RECALL CAMPAIGN BULLETIN

NTB16-053

VOLUNTARY SAFETY RECALL CAMPAIGN 2013-2016 SENTRA OCCUPANT CLASSIFICATION SYSTEM REPROGRAMMING SEATBELT BUCKLE BRACKET INSTALLATION

APPLIED VEHICLE: 2013-2016 Sentra (B17)

Front Passenger Air Bag Status Light

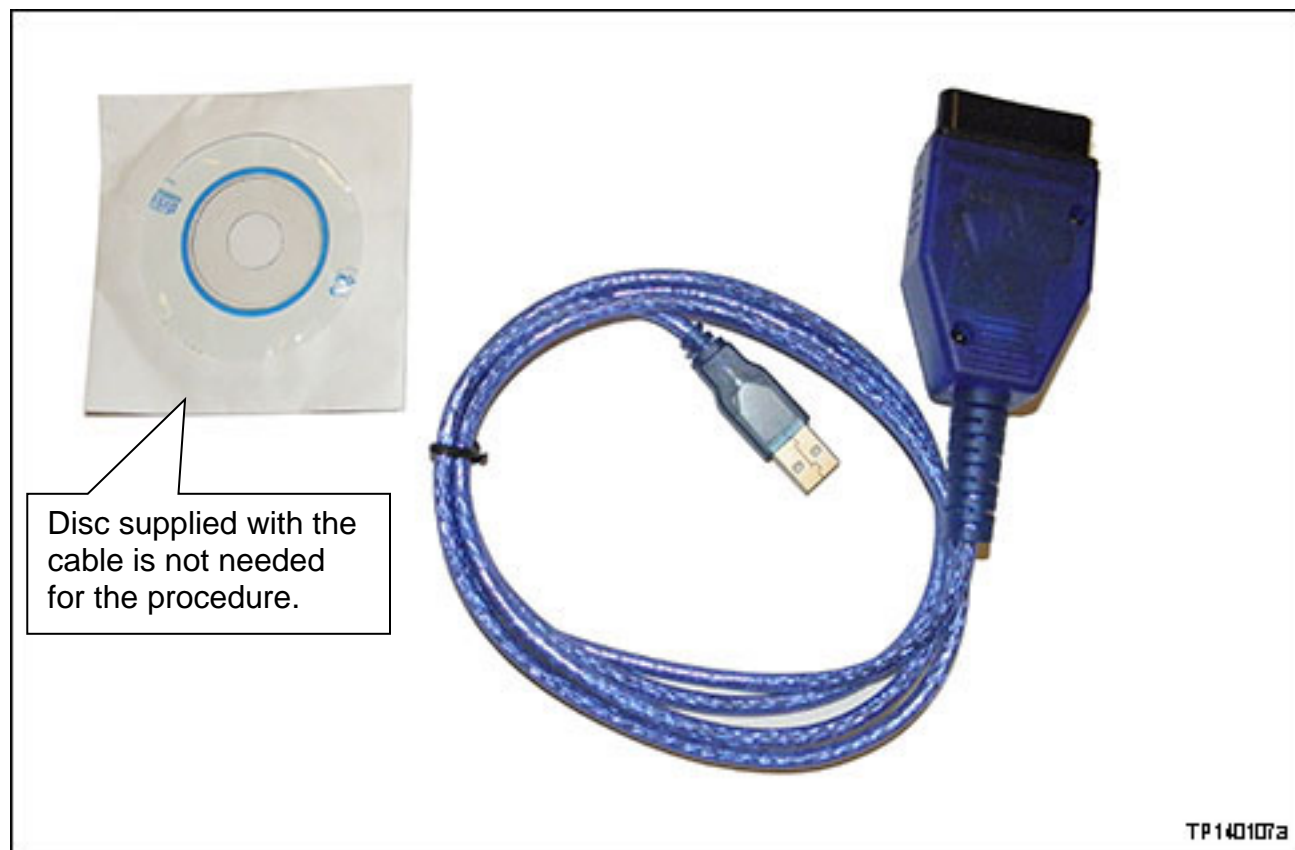
Performing the procedures in the bulletin (campaign R1608) changes the operation of the passenger air bag status light.

- After performing this campaign, the passenger air bag status light will be ON (illuminated) when the front passenger seat is empty.
